Cero Company Limited Prague Czechslovakia

MANDATORY BULLETIN No. L 23/012a

Effectivity: TheL23	Super	Blaník	sailplanes	S/Nos.:897501÷897520,	907601:907630,
9077	01:907	730, 91 ⁻	7801÷917830.	, 917901÷917930.

Reason: Cases of damage of the backrest adjustment strap at the buckle

Fig. 1 - View in the forward cockpit from above.

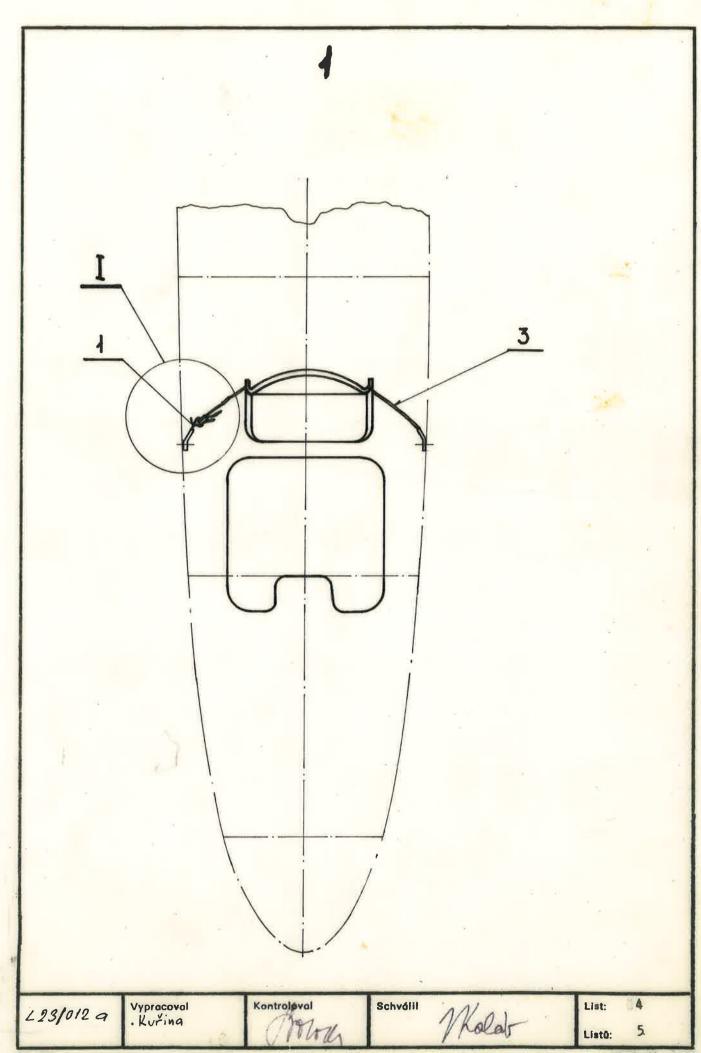
of the front pilot were evidenced in operation.

Description: A strap with smooth rings will be used. In production incorpo-

- 1. In accordance with the fig. 1 det. I remove the original shortening strap pos. 1 and replace it by a new one pos. 2, fig. 2 det. I. If the original strap pos. 3 is in a good condition, shorten it to the required length with regard to the bent and length of 630 and sew the ring pos. 4 in using the polyamid thread in accordance with fig. 2. Seal-in the end of strap before the sew in. In case the original strap pos. 3 is damaged, replace it by a new one.
- 2. Connect both straps together (see fig. 2.).
